80 Narrabeen Park Parade Warriewood.

Re: Bushfire Assessment Review – 80 Narrabeen Park Parade Warriewood.

S4.55 MODIFICATION CHANGES

PROPOSED ALTERATIONS AND ADDITIONS
80 NARRABEEN PARK PARADE, WARRIEWOOD 2102
CLIENT:
JON + FIONA BROCK
DRAWING TITLE:
SITE PLAN

SITE ANALYSIS PLAN

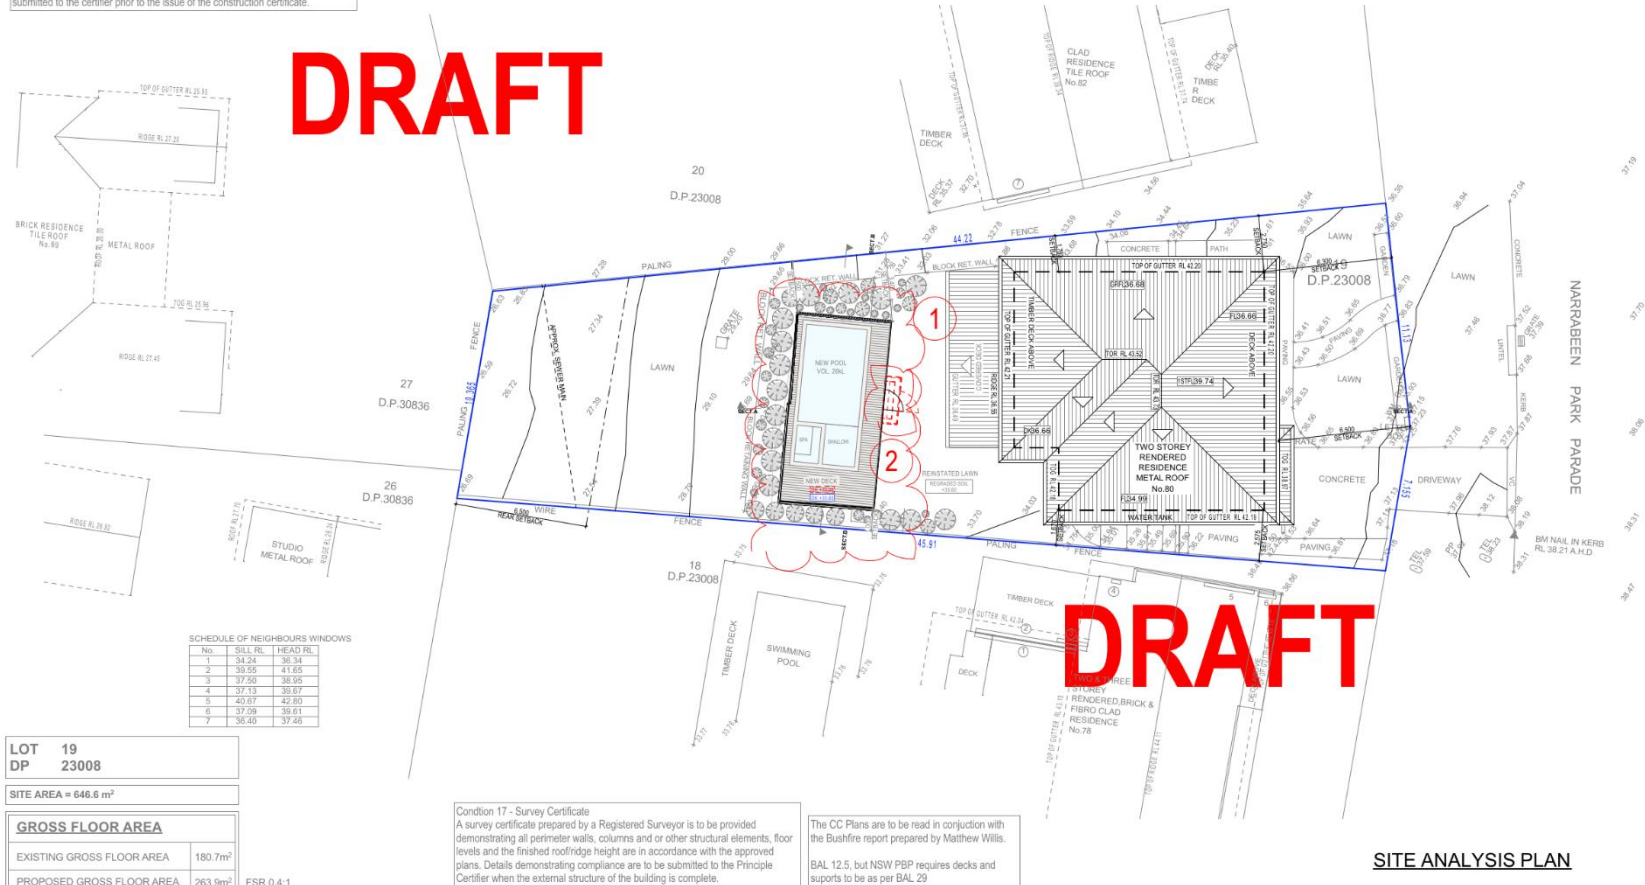
1. POOL COPING & STRUCTURE RAISED
2. POOL ENTRY STAIRS REMOVED
3. PROPOSED WINDOW

PROPOSED FIRST FLOOR PLAN

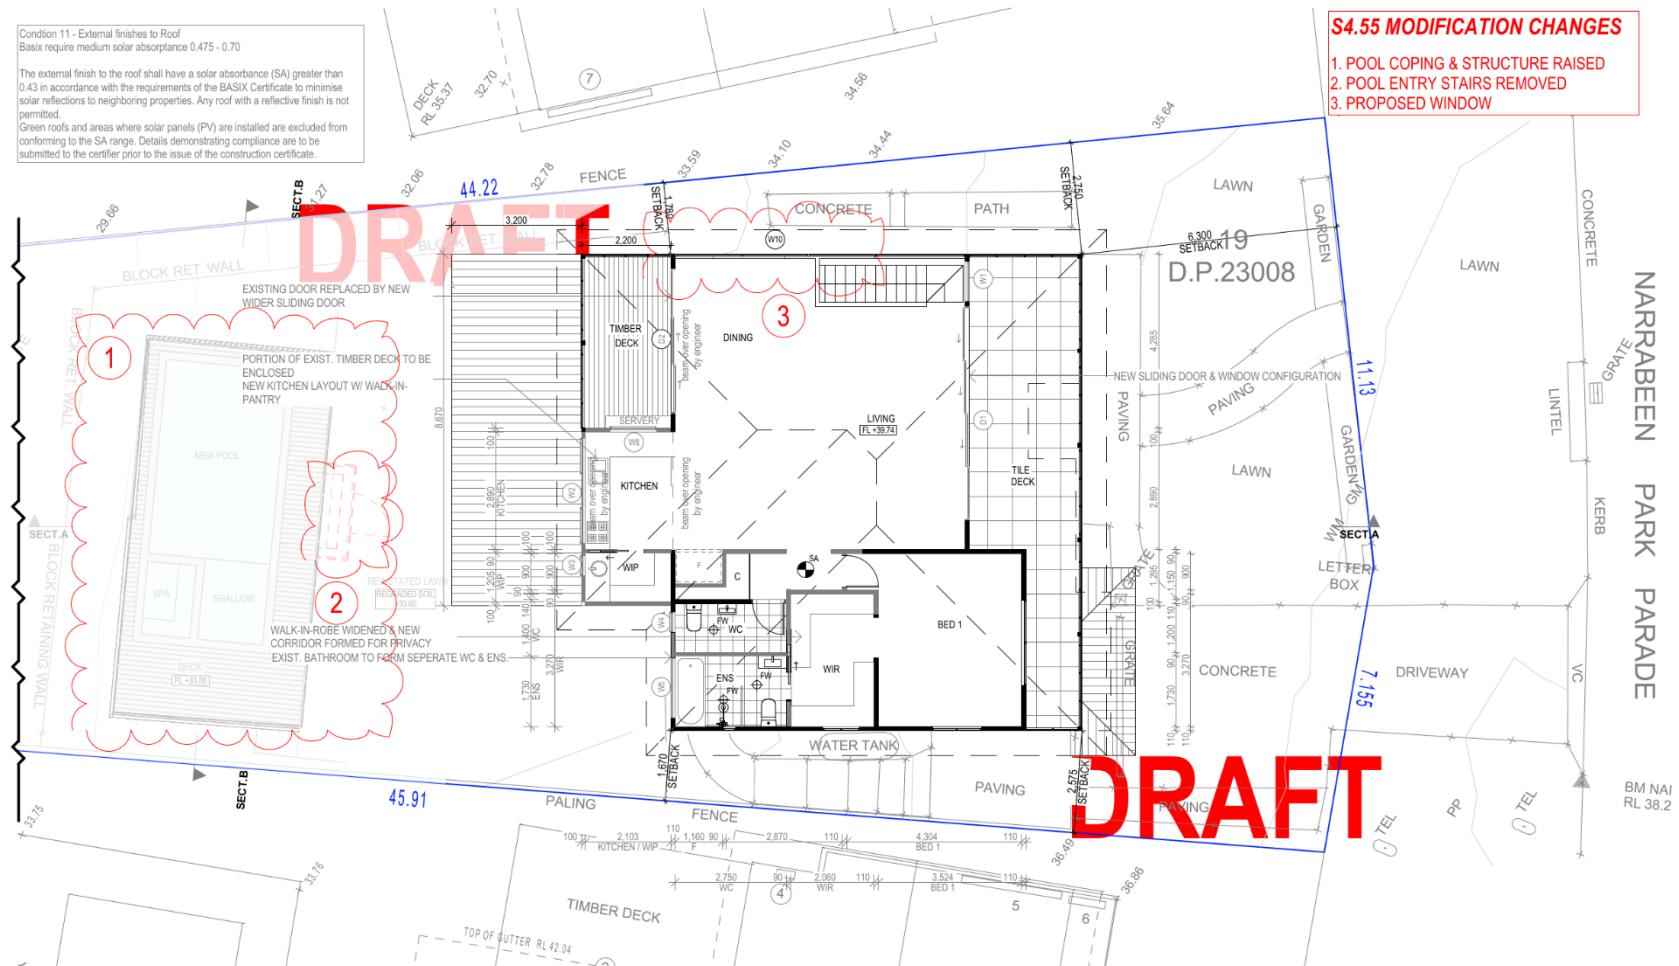
S4.55 MODIFICATION CHANGES

1. POOL COPING & STRUCTURE RAISED
2. POOL ENTRY STAIRS REMOVED
3. PROPOSED WINDOW

PROPOSED GROUND FLOOR PLAN

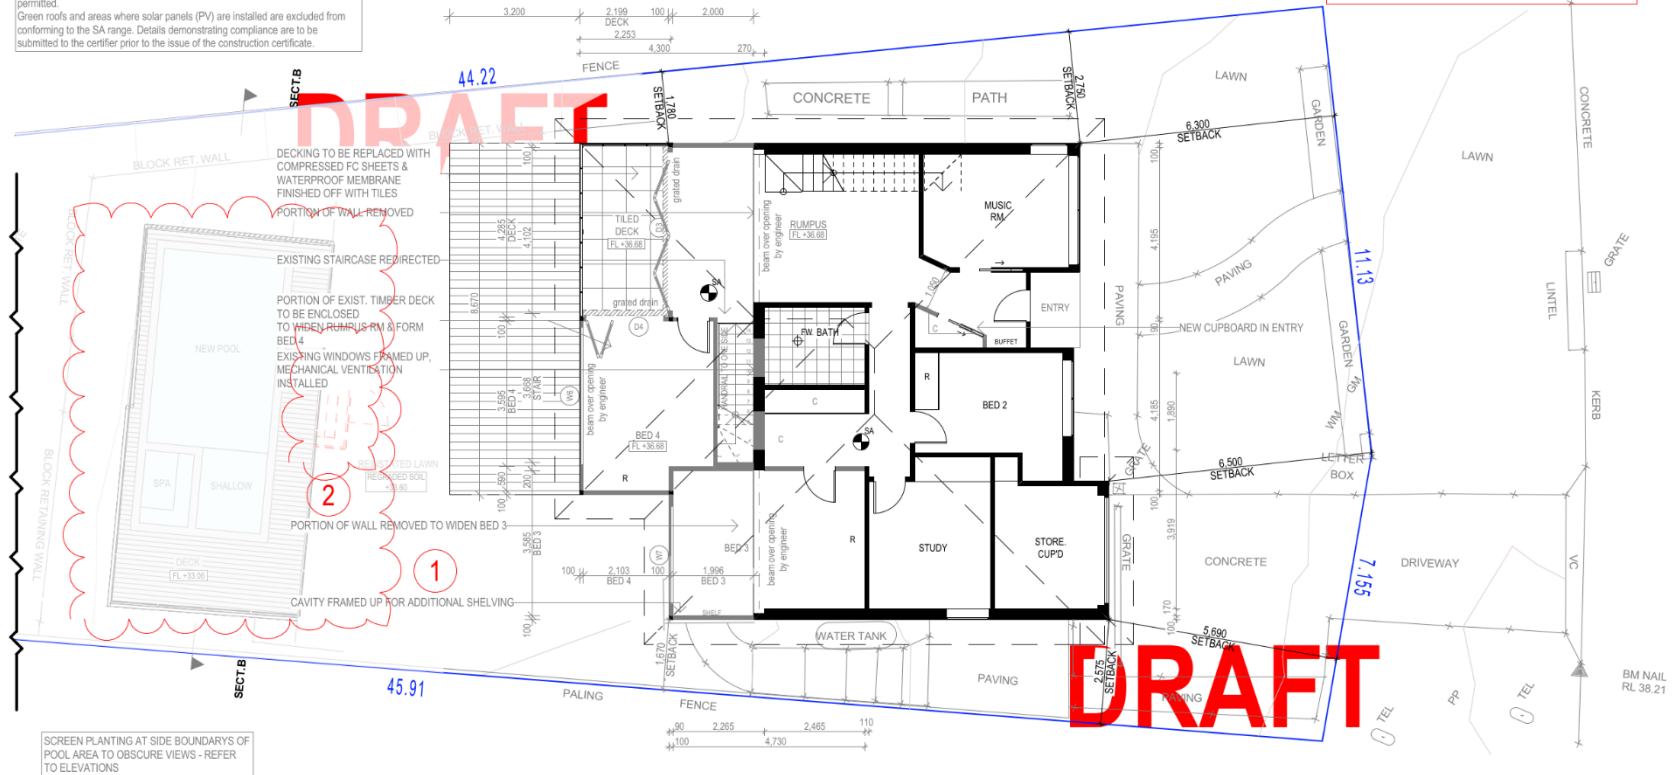
S4.55 MODIFICATION CHANGES

1. POOL COPING & STRUCTURE RAISED
2. POOL ENTRY STAIRS REMOVED
3. PROPOSED WINDOW
